Lower Ground Floor Plan - Proposed

14 Eton Road

05/101

I Lower Ground Floor Plan
05/101 1:100

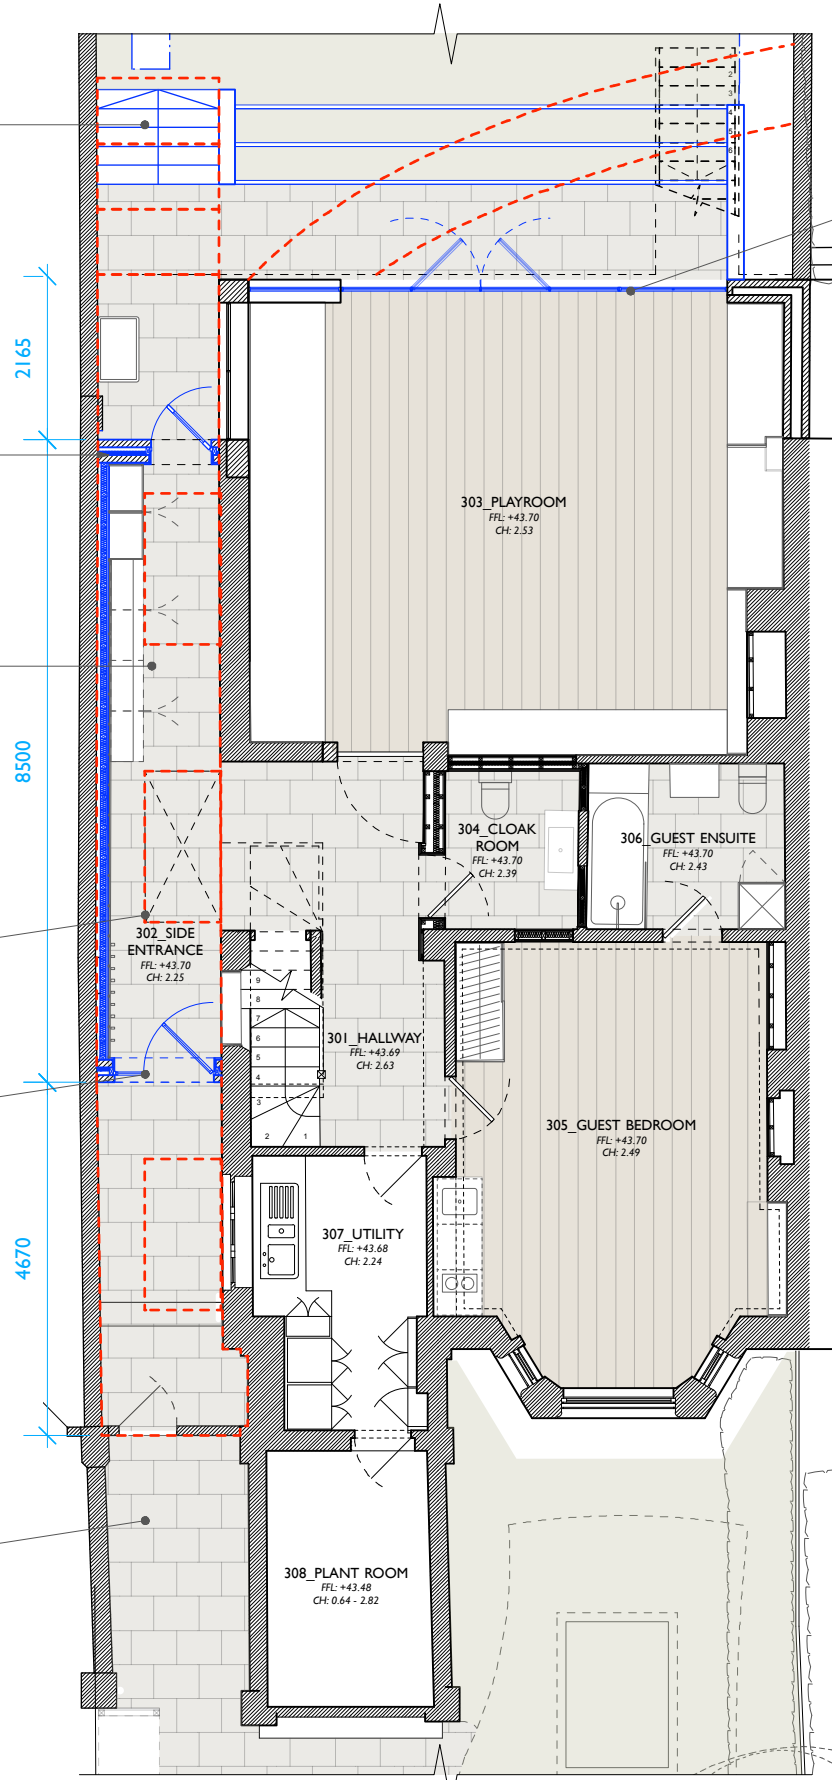
UPDATED HARD AND SOFT LANDSCAPING. REFER TO GARDEN PLAN 14ER/05/120

REAR CRITTALL GLAZING UPDATED TO HINGED DOORS FROM SLIDING

NEW BRICK CAVITY WALLS TO EITHER END OF NEW SIDE EXTENSION

UPDATED SIDE EXTENSION: REDUCED IN LENGTH AND HEIGHT: - NEW LIGHTWEIGHT TIMBER ROOF STRUCTURE TO USE EXSITNG BOUNDARY WALL STRUCTURE IF AND WHERE POSSIBLE. 1 NO. NEW ROOFLIGHT

REDUCE 3NO. ROOFLIGHTS TO 1NO. 2M X 1M

UPDATE CRITTALL STEEL AND GLASS ENTRANCE DOOR

YORKSTONE SLABS TO ENTRANCE IN EXISTING LOCATION OF HARDSTANDING
